**BAY BRIDGE DESIGN TASK FORCE
ENGINEERING AND DESIGN
ADVISORY PANEL
Friday, May 29, 1998
1 p.m.
Joseph P. Bort MetroCenter Auditorium
101 Eighth Street
Oakland, California 94607**

FINAL AGENDA

BAY BRIDGE DESIGN TASK FORCE
Engineering and Design Advisory Panel
May 18, 1998 Meeting
Metropolitan Transportation Commission

Structure Type Decision Tree

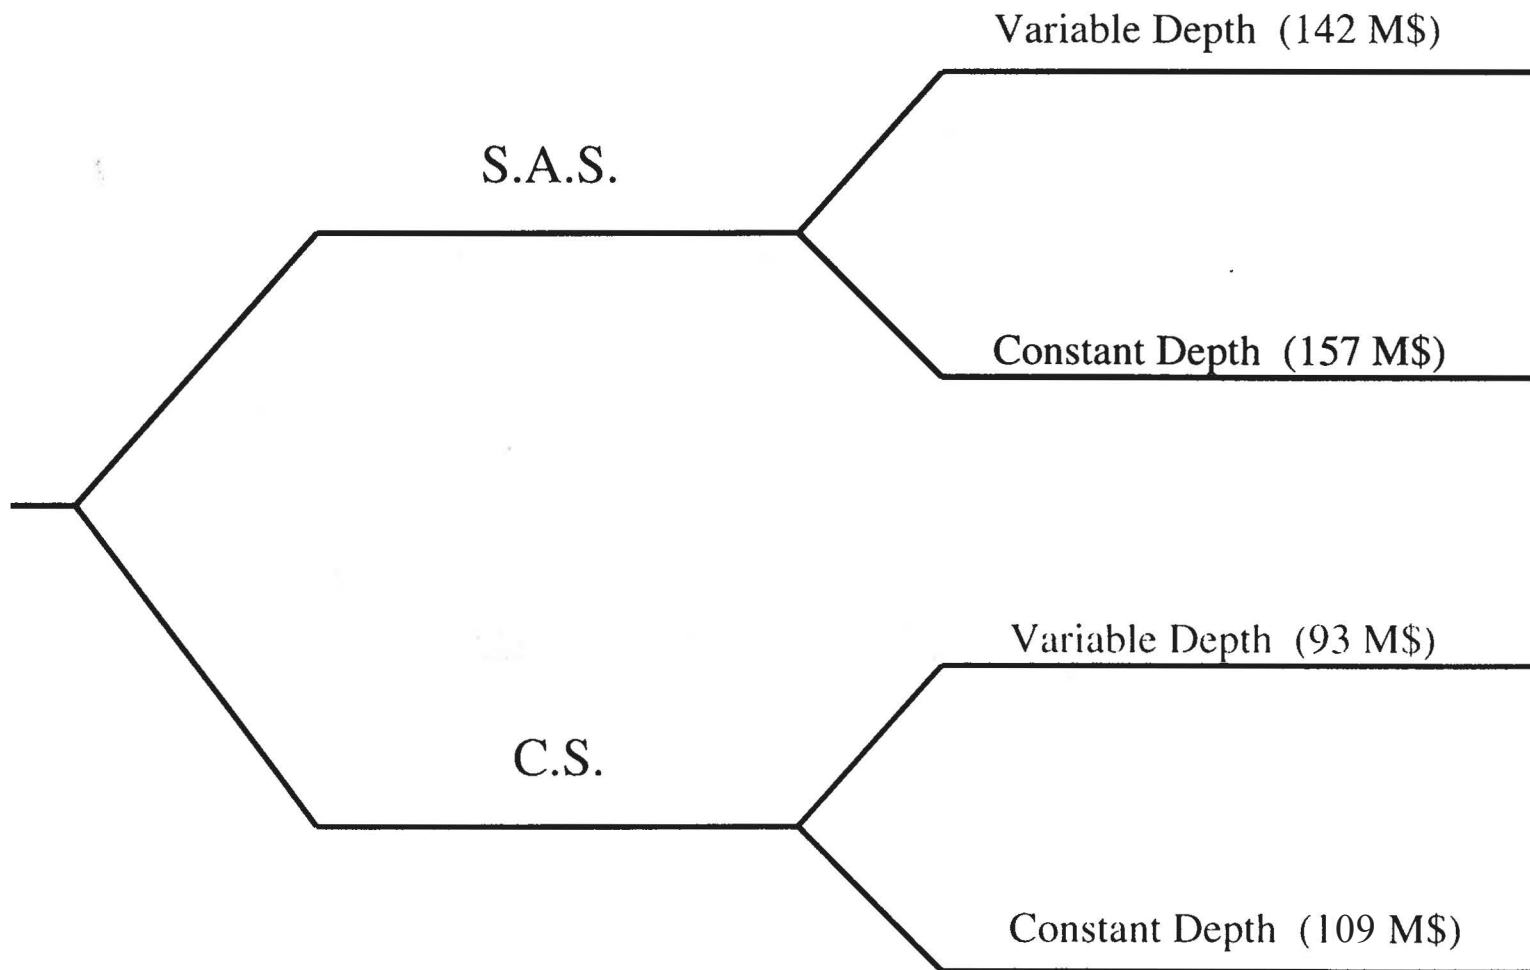
Joseph Nicoletti refrained from making his own comments because of his role as chairman, but he read comments that had been submitted to him by Vice Chair John Kriken. Mr. Kriken expressed his preferences for single instead of dual towers, asymmetrical main/back spans instead of symmetrical spans, steel instead of concrete, two bicycle/pedestrian paths instead of a single path, and a depressed path instead of one at deck level, although the depressed path should be visible from the deck for safety reasons.

Jeffrey Heller noted that the cost differential among the design options was greater than the incremental cost of adding bicycle/pedestrian access. He said the single tower designs were more harmonious with the single towers of the western span, therefore he favored those designs and, between the two single tower options, he favored the single tower cable-stayed bridge. He expressed support for consistent profile for the main span and viaduct deck, but said he was willing to consider a haunched skyway if cost savings could be achieved.

Bicycle/Pedestrian Facility Decision Tree

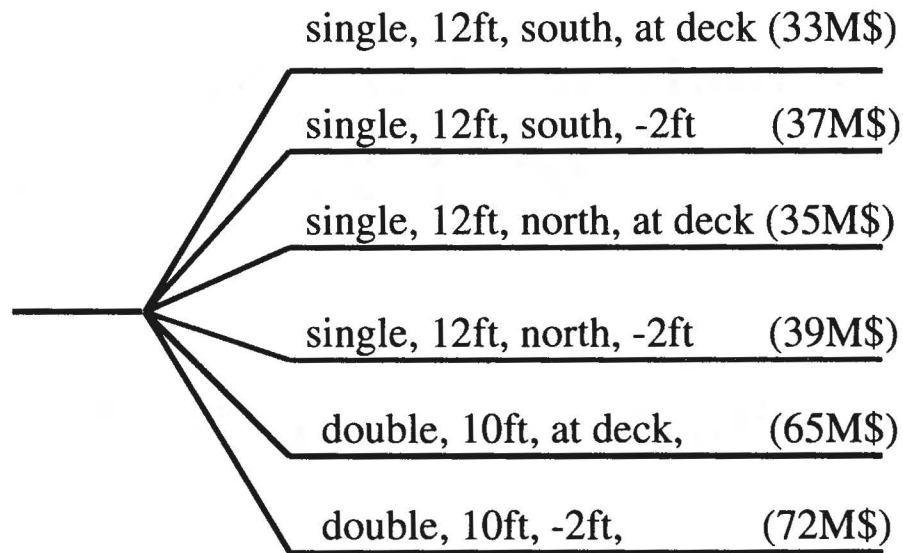
Bay Bridge Bicycle/Pedestrian Advisory Committee
Pathway Recommendation to the
Engineering and Design Advisory Panel
May 29, 1998

Two paths, each at least ten feet wide, approximately 12" above deck level.
Cost: On the order of \$70 million.

If EDAP does not choose to include two paths in the final bridge design, then we recommend one 15-foot wide path on the south side of the new span, approximately 12" above deck level.
Cost: On the order of \$48 million.

If a raised pathway is unacceptable to EDAP, we would prefer a below deck pathway in which the total height of the solid barrier plus the depression is at least six feet. This could be accomplished, for instance, by depressing the path 3-1/2 feet given a standard 2'8" concrete barrier.
